July 10, 2025

### Addendum No. 2

#### **Diablo Road Trail and Drainage Improvement Project Project No. C-055**

SHEET NUMBER  
**2**  
OF 22 SHEETS  
PROJECT NO.  
8870.000.011

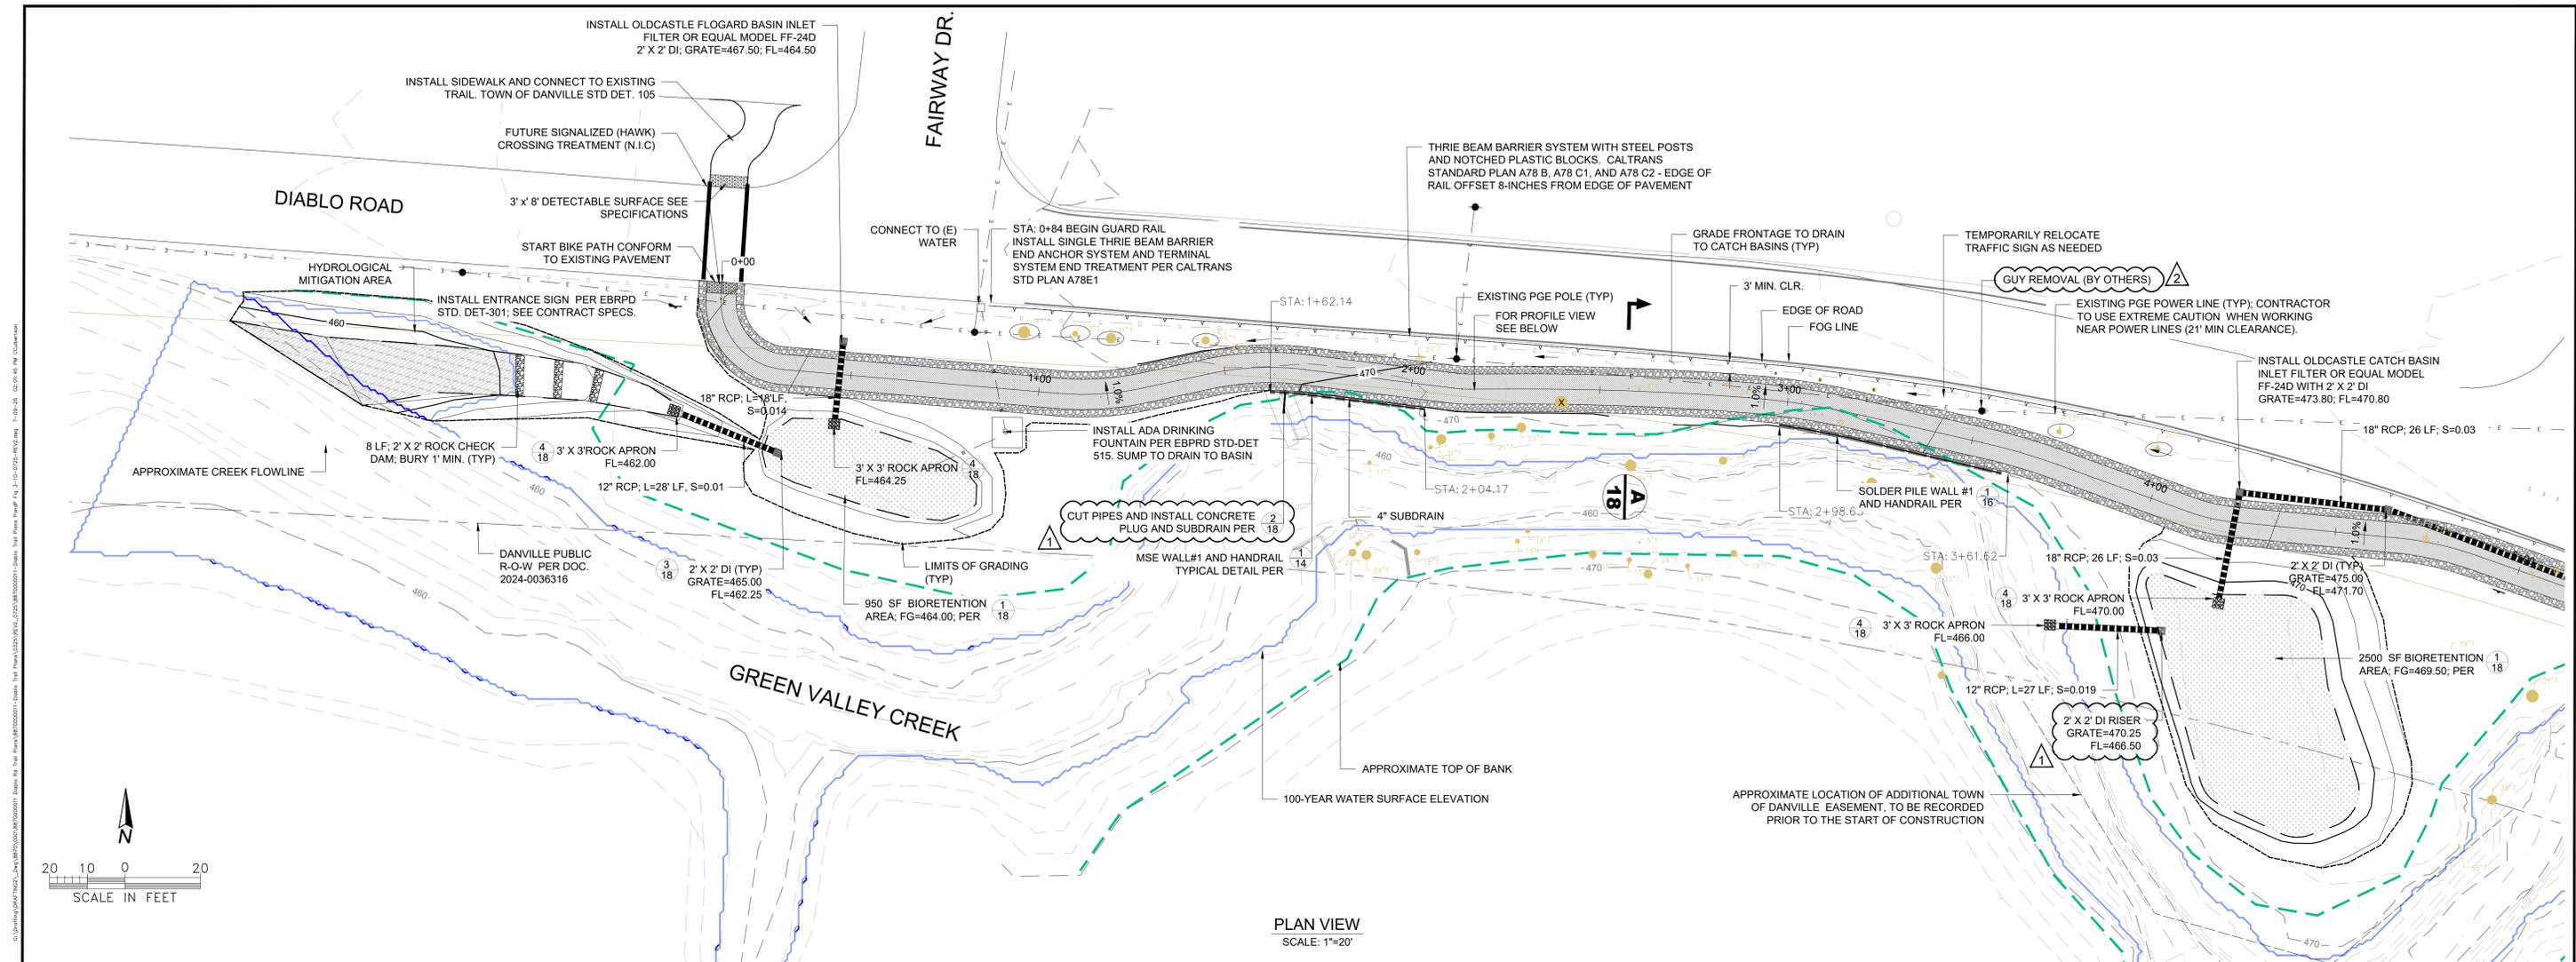
48- On Plan Sheet 2, the legend shows tree removals to be a yellow circle with an X. All other trees are either to be protected or to be removed by other.

49- There is a rectangular area denoted by a broken line, with an arrow saying, "Remove Cluster of Trees in this Area". It lists 7 trees to remove, with no symbols.

50- Secondly, the plan sheet contains the above-mentioned yellow circles with an X, but not all of them are labeled for removal. There are others labeled for removal but marked to be removed by others per "EXPLANATION".

- a. The contractor shall remove all 7 trees in this area.

- a. See response to item 48. Tree removals are specifically called out on Sheets 19 and 20 in Addendum 1 and other symbols have been removed from these sheets.

**PLAN AND PROFILE STA: 0+00 - 5+00**  
IMPROVEMENT PLANS FOR DIABLO ROAD TRAIL  
TOWN OF DANVILLE, CALIFORNIA

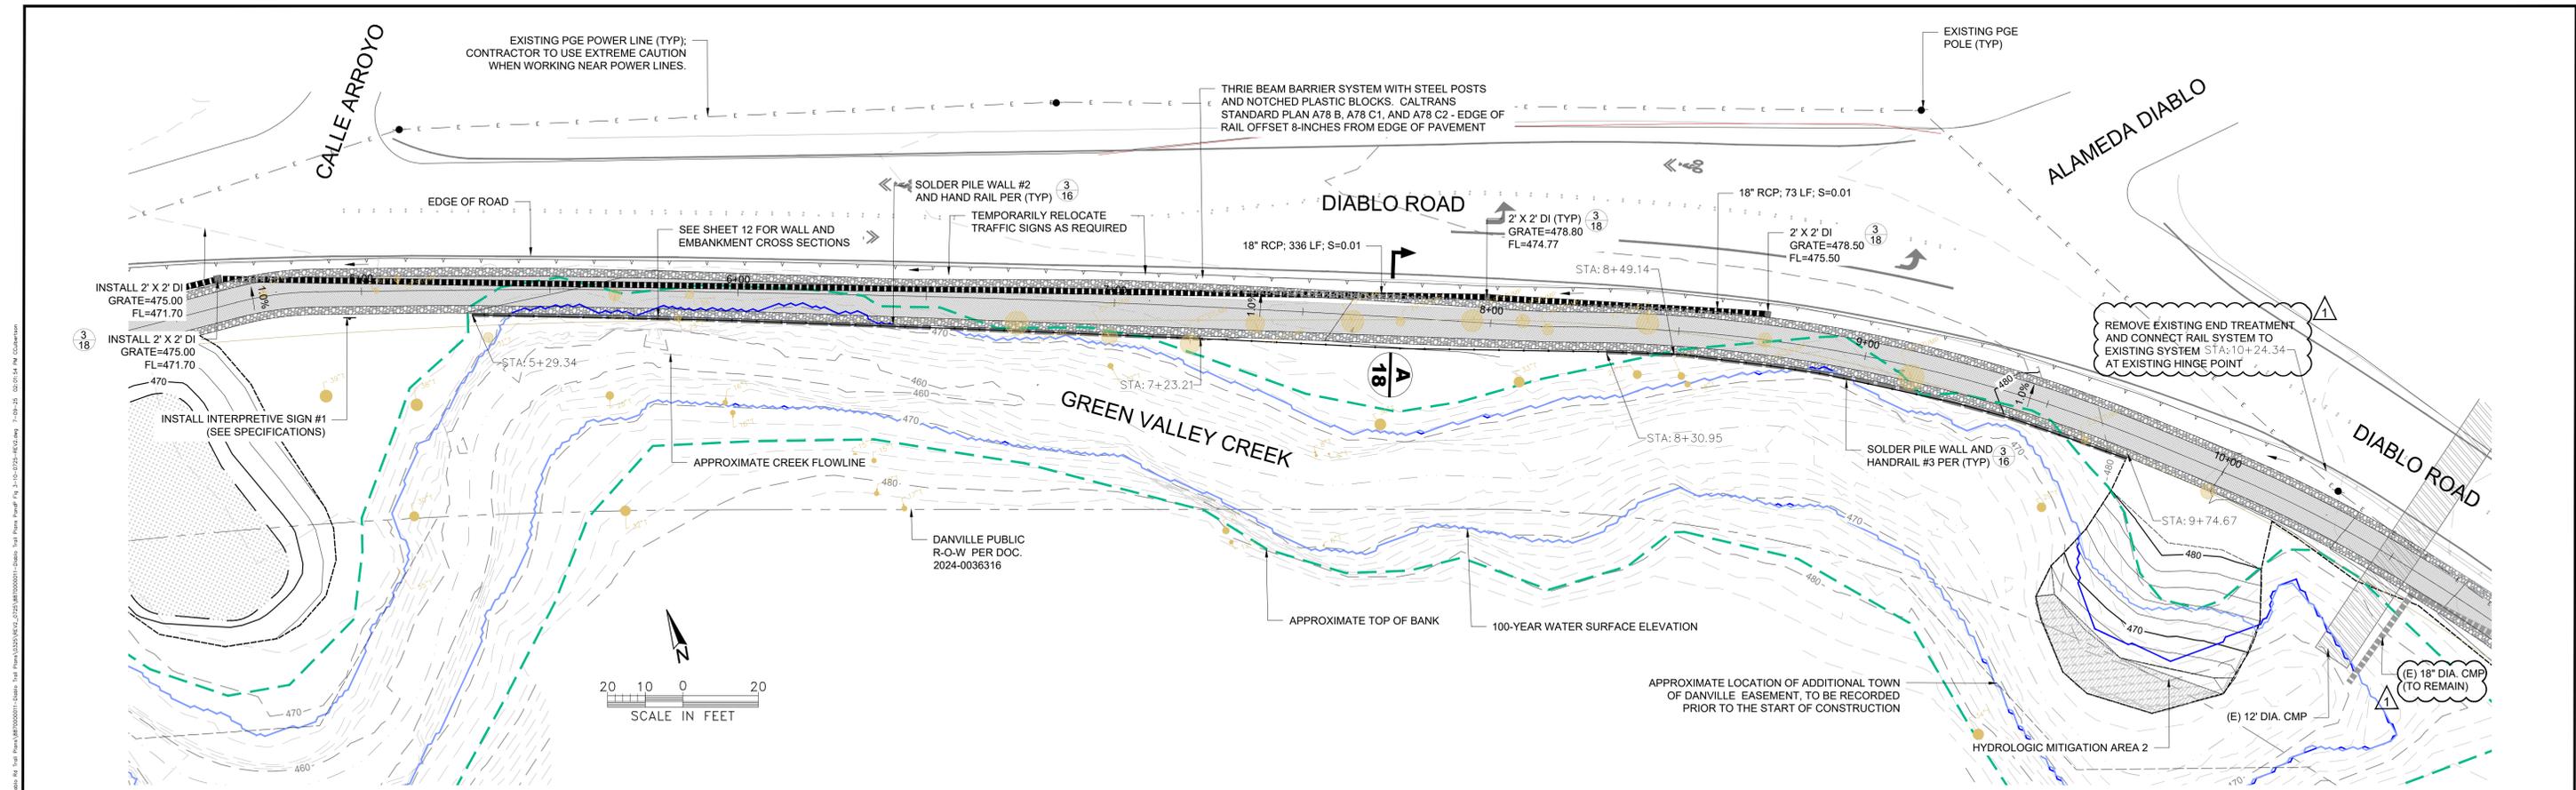
54- There are several rock check dams shown on plan sheet 3, how do they get paid.

76- Plan Sheet 3 shows 3 each 2'x2' rock check dams to be installed. There is no bid item for this work nor does the measurement and payment for Bid Item 21 address these check dams. Please confirm these check dams are to be measured and paid for under Bid Item 21, or please provide a bid item for this work to be performed under.

- a. Rock check dams are paid from bid item 21 as added in Addendum 2.

- a. See response to question 54..

**PLAN AND PROFILE STA: 22+00 - 28+00**  
IMPROVEMENT PLANS FOR DIABLO ROAD TRAIL  
TOWN OF DANVILLE, CALIFORNIA

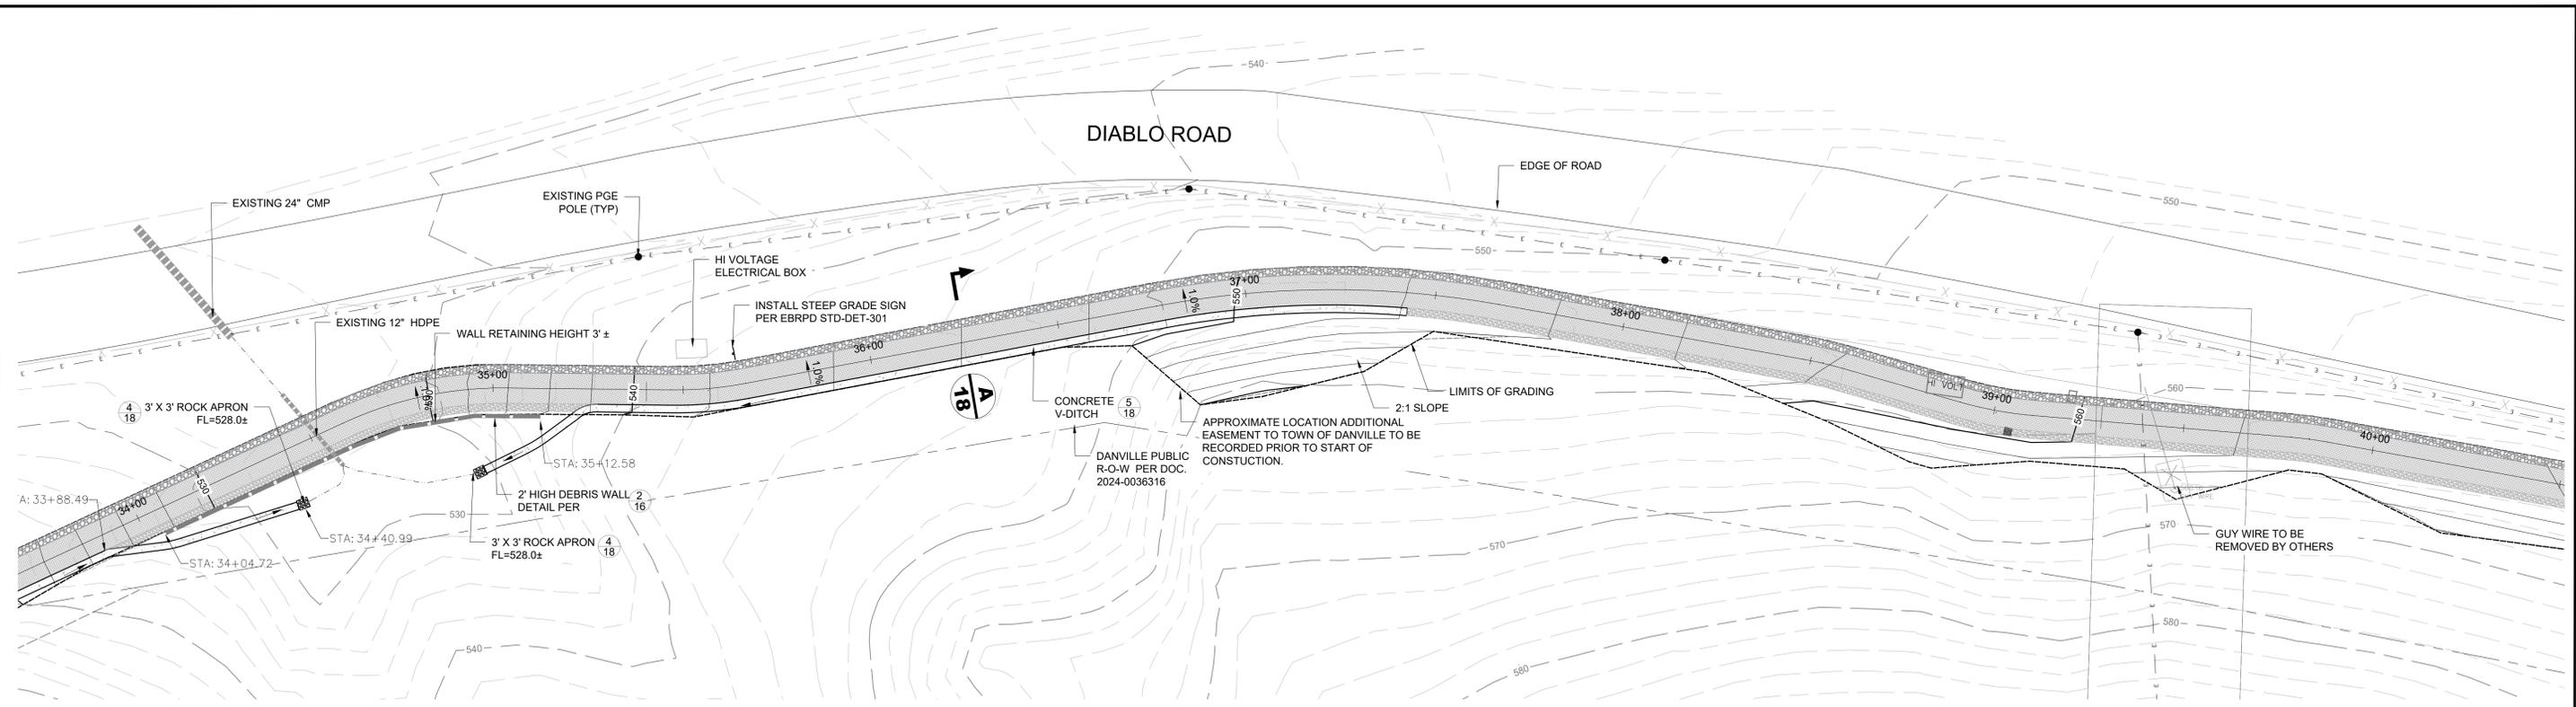
73- Please describe in detail what work takes place in the Self Retaining Area shown on plan sheets 7 & 10 and how does it get paid?

- a. Self retaining areas are slightly depressed areas that will require grading and hydroseeding ,and are paid for under the earthwork/hydroseed item. However, the self retaining area shown on Sheet 10 only needs grades to be restored to the pre-project condition and hydroseeded if disturbed.

1 TYPICAL SOLDIER PILE WALL DETAIL  
NO SCALE

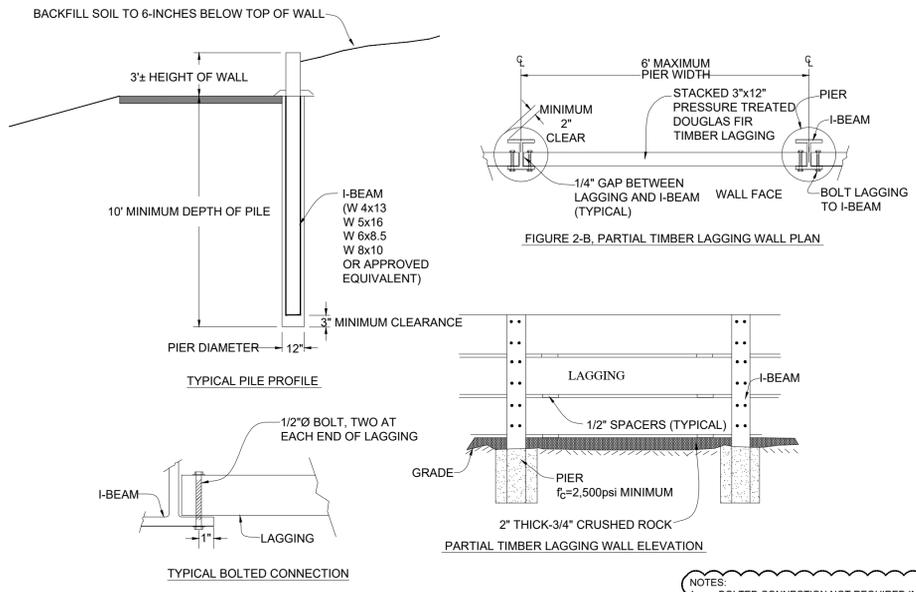
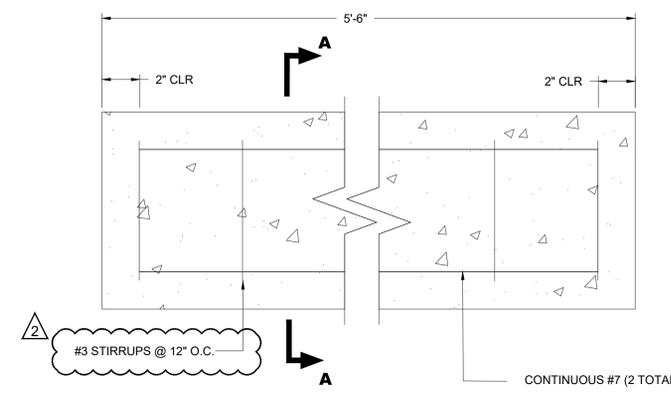
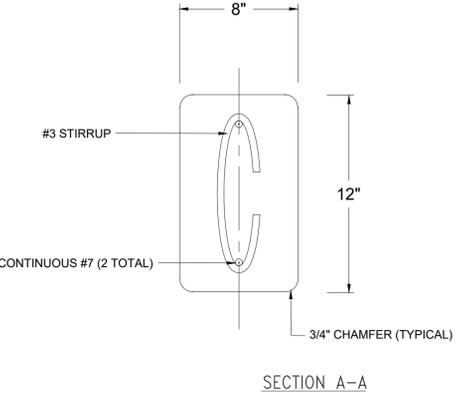
46 - Plan Sheet 16, Detail 1 shows an additional 4 layers of Tensar InterAx NX 650 Geogrid to be installed in addition to the geogrid to be installed under the AB. Do these 4 additional layers get installed along the entire length of the trail, or do they only get installed adjacent to the soldier pile walls? How are these 4 additional layers of geogrid paid?

47 - Plan Sheet 16, Detail 1 shows "TEMPORARY SHORING (LAGGING) AS REQUIRED (BY OTHERS)". This note indicates this would be performed by other forces outside of this contract. Please confirm the Town's intent of this note.

52- Looking at the typical soldier pile wall detail on sheet 16.

- a. We have removed this call out in Addendum 2 from the plans.
